**UNITED STATES
NUCLEAR REGULATORY COMMISSION**
WASHINGTON, D.C. 20555-0001

**SUBJECT: CALLAWAY PLANT, UNIT 1 – SAFETY EVALUATION REGARDING
IMPLEMENTATION OF MITIGATING STRATEGIES AND RELIABLE SPENT
FUEL POOL INSTRUMENTATION RELATED TO ORDERS EA-12-049 AND
EA-12-051 (CAC NOS. MF0772, AND MF0773)**

Figure 1 - Callaway SFP Levels of Monitoring

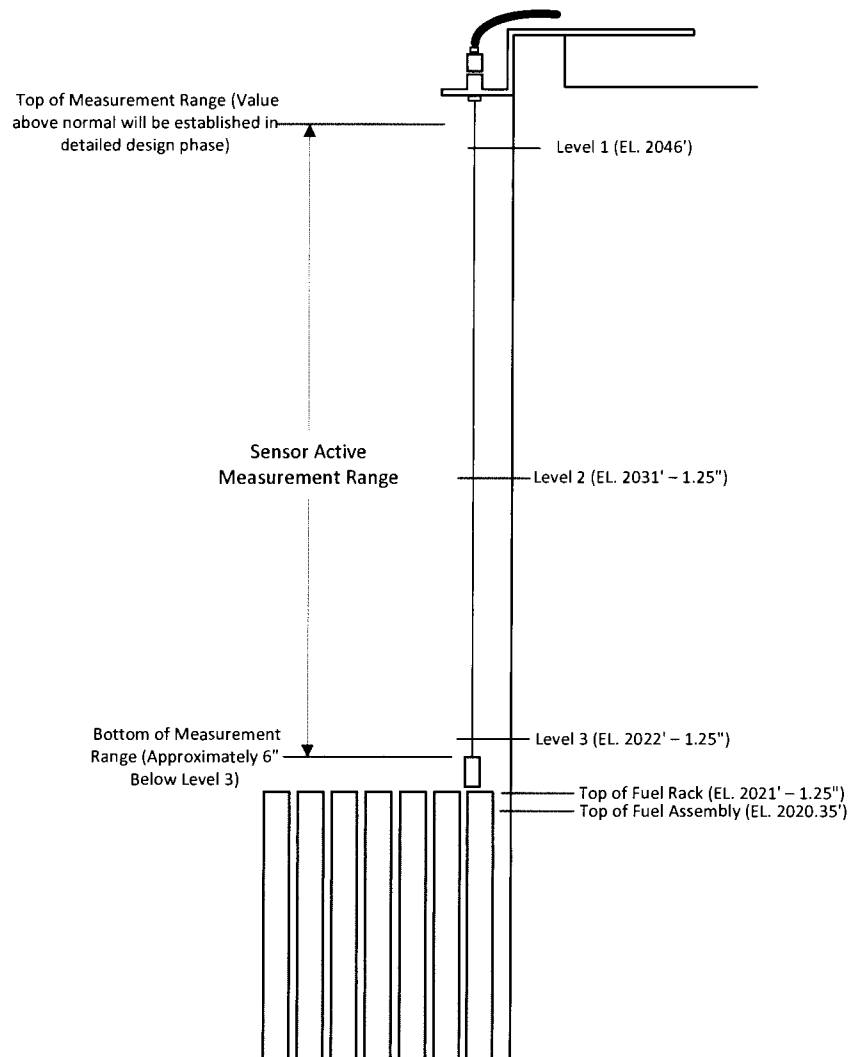
In its compliance letter dated July 6, 2016 [Reference 35], the licensee further provided the basis for the designated Level 1 as follows: Calculation M-EC-48, "Minimum Safety Limit for LSL 57 & 58," Revision 0, concludes that the SFP water elevation that is sufficient for the pump's required NPSH [Net Positive Suction Head] is elevation 2043' 6". Level 1 indication is at the normal SFP water operating level of elevation 2046' 0". This confirms that Level 1 has sufficiently covered the calculated level to maintain the pump's required NPSH. In the same letter, the licensee also provided a sketch depicting Levels 1, 2, and 3 and SFP level measurement range as shown in the figure below (Figure 1 - Callaway SFP Levels of Monitoring).

The NRC staff found the licensee selection of the SFP measurement levels adequate based on the following:
